REMARKS

Appl. No. 09/602,690
Amdt. dated May 17, 2004
Annotated Sheet Showing Changes

FIGURE 3A

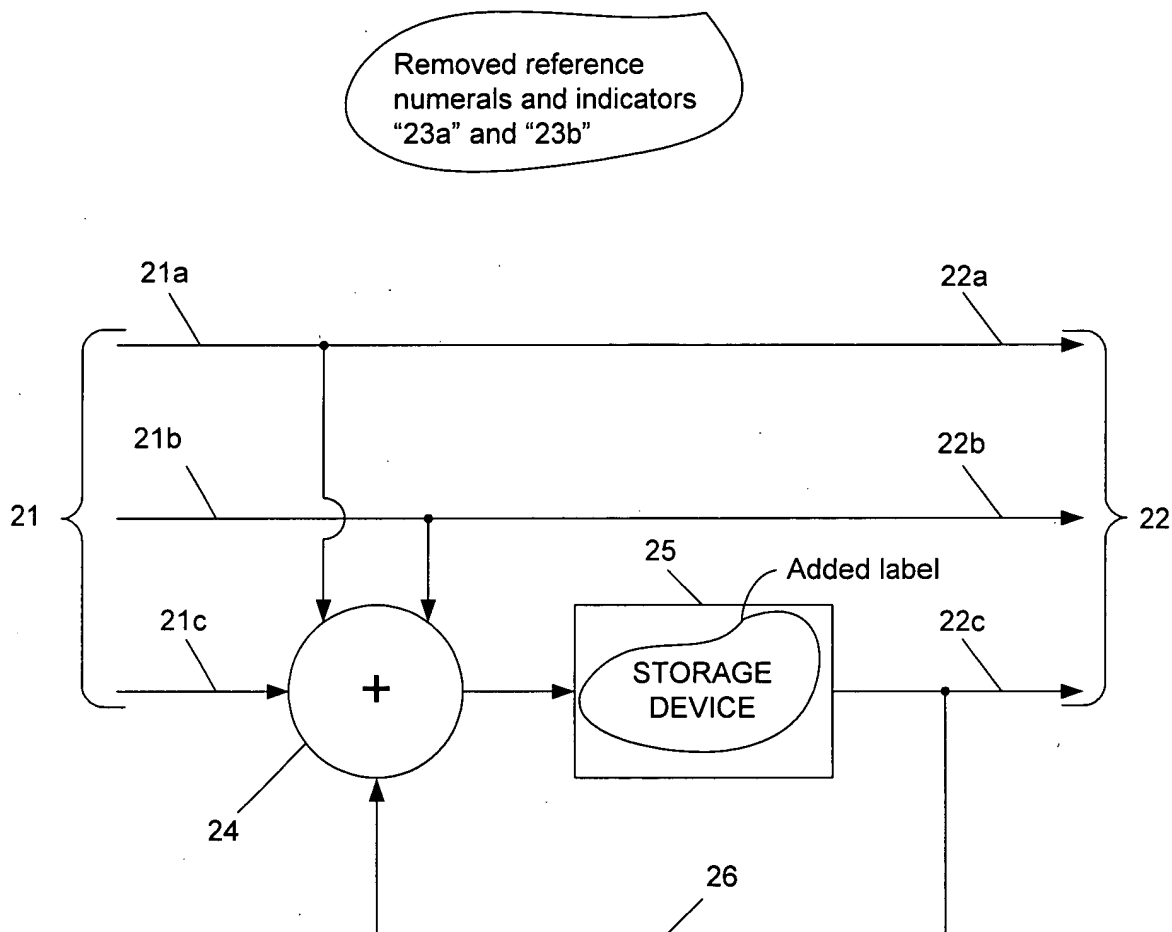
Removed arrows from
reference indicators 21a,
21b, 21c, 22a, 22b, 22c, 24

FIGURE 5

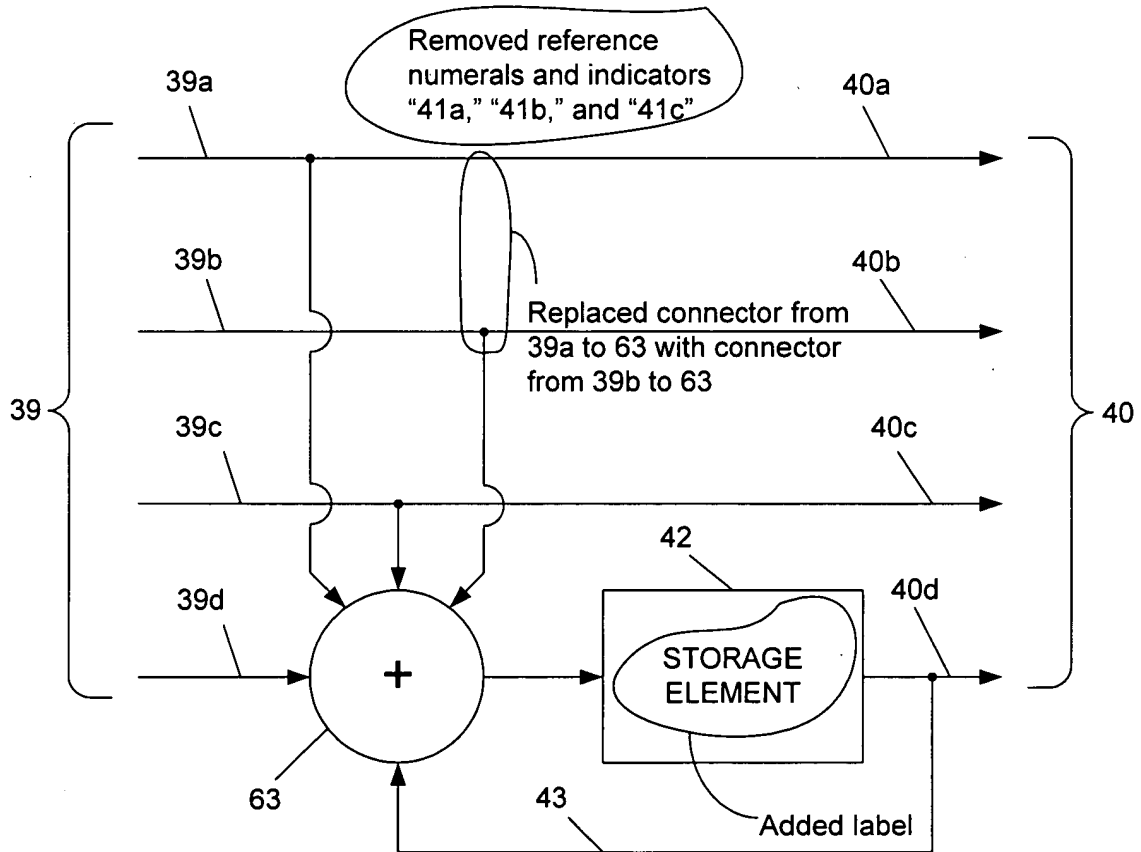
In Figure 5, the original drawing contained an obvious drafting error showing a connector from 39a to 63. In the amended Figure 5, the error has been corrected by replacing the connector with a new connector from 39b to 63, as described in the spec on page 8, lines 30-31.

FIGURE 6

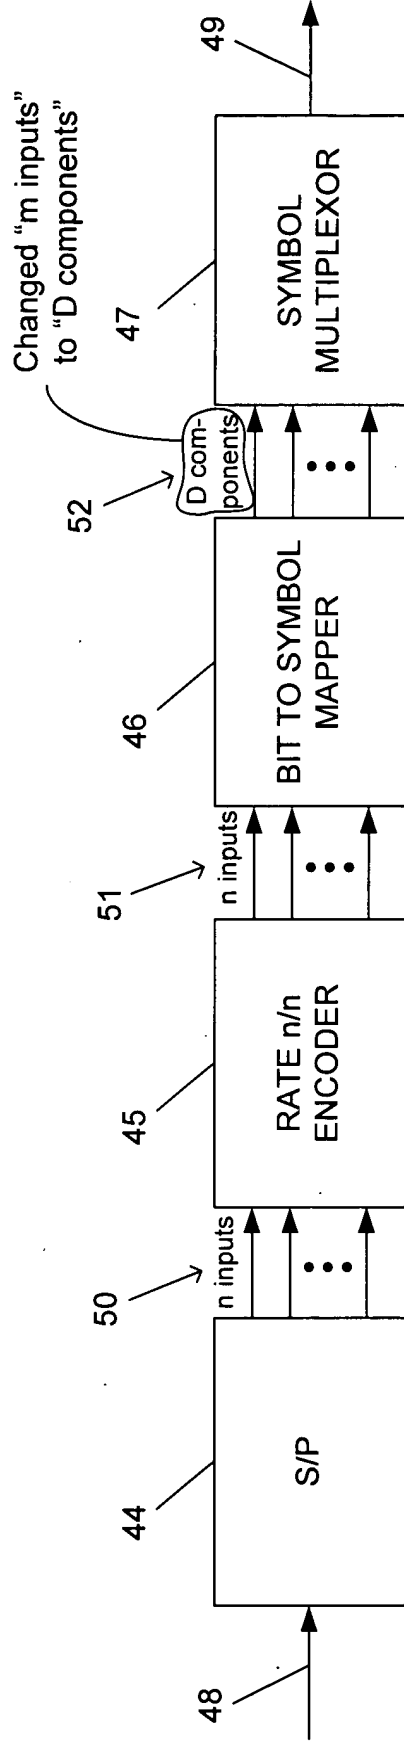
In Figure 6, the original drawing contained an obvious drafting error, mislabeling inputs 52 as "m inputs." In the amended Figure 6, the error has been corrected by replacing the label with a new label "D components," as described in the spec on page 9, lines 18-24.

Removed arrows from
reference indicators 48, 49

FIGURE 9B

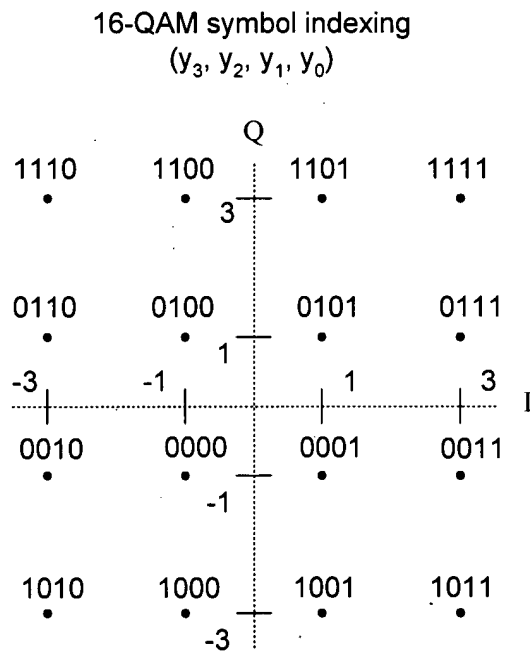
Centered
Figure 9B

FIGURE 10

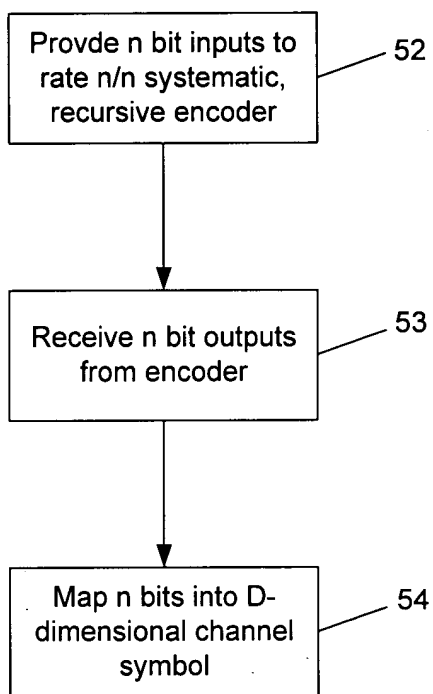
Centered
Figure 10

FIGURE 11B

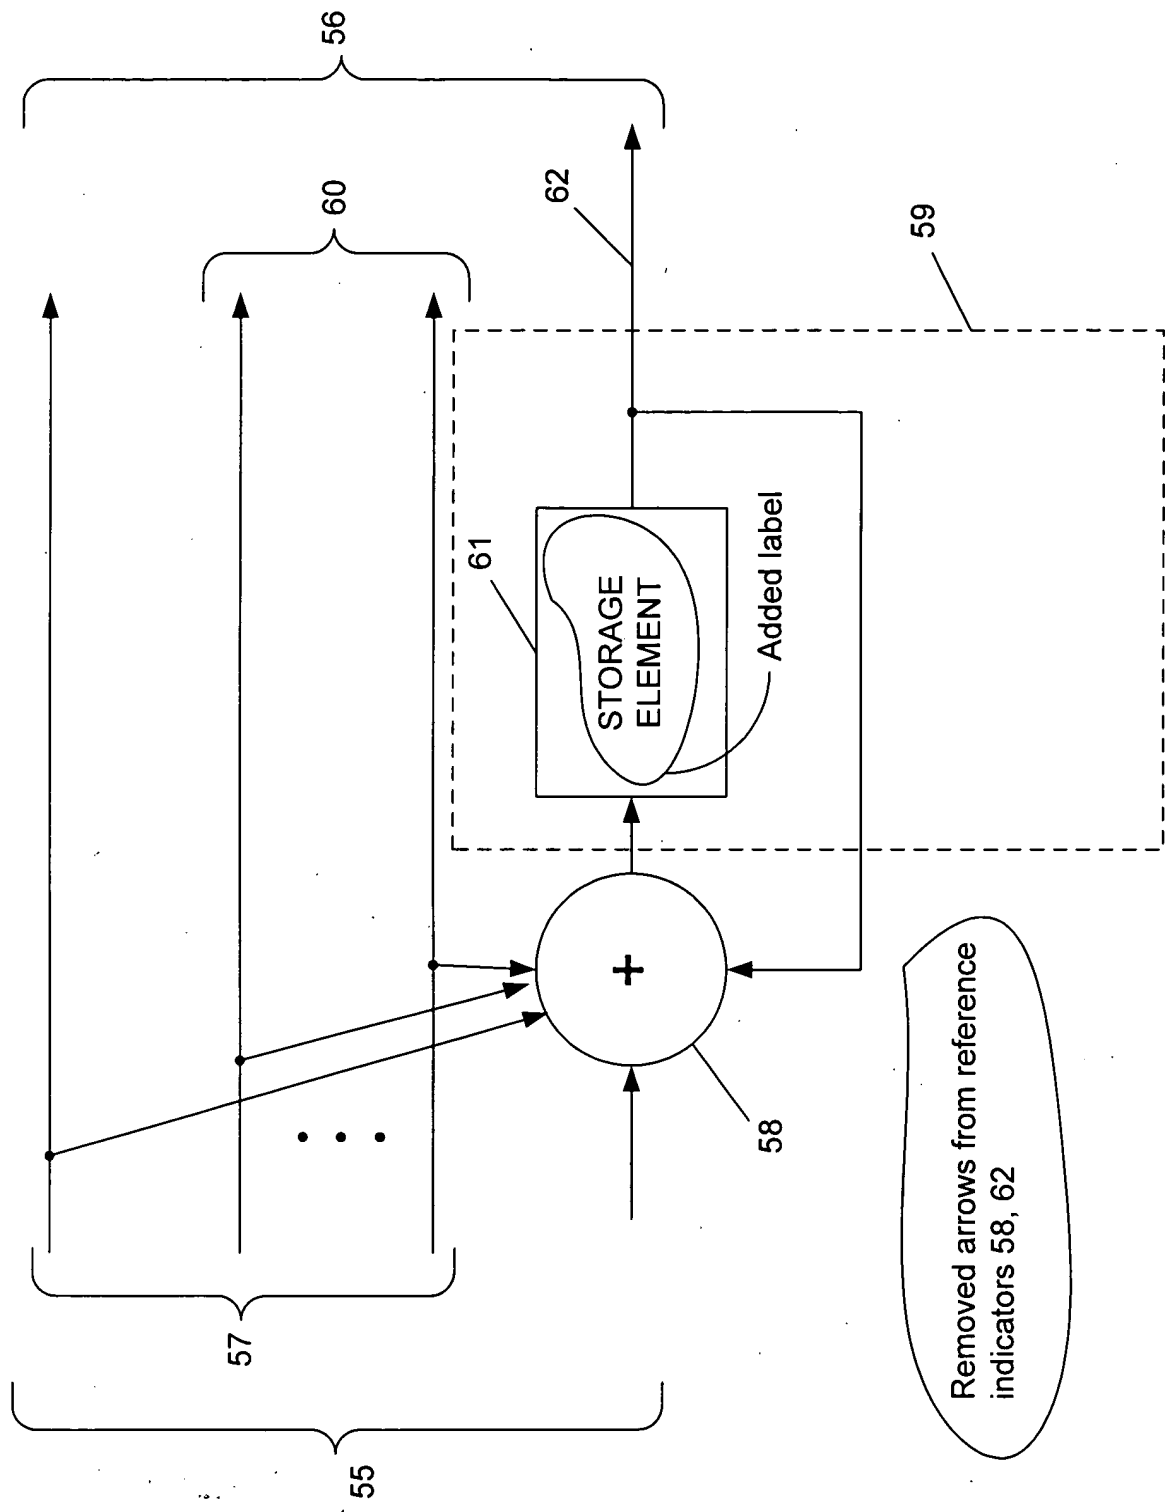
Deleted reference numeral and indicator "200"

FIGURE 16

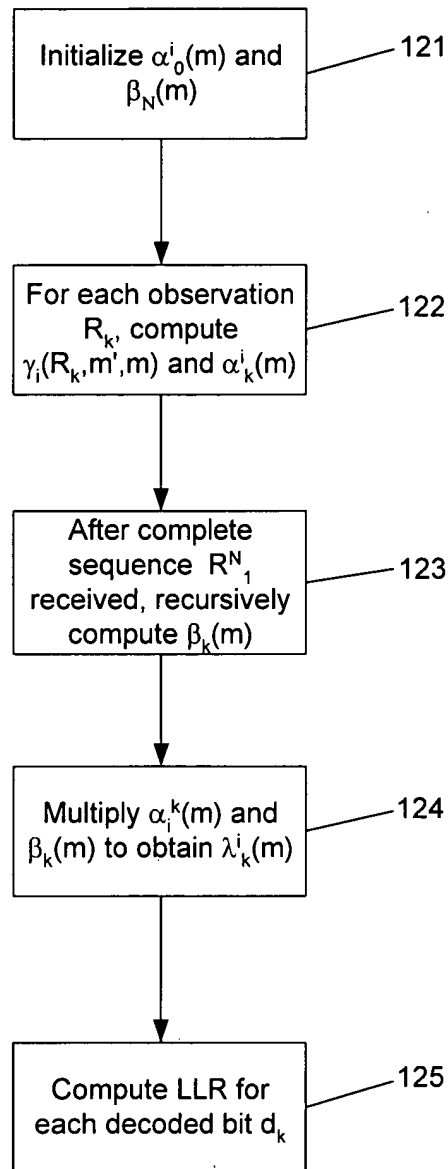
Centered
Figure 16
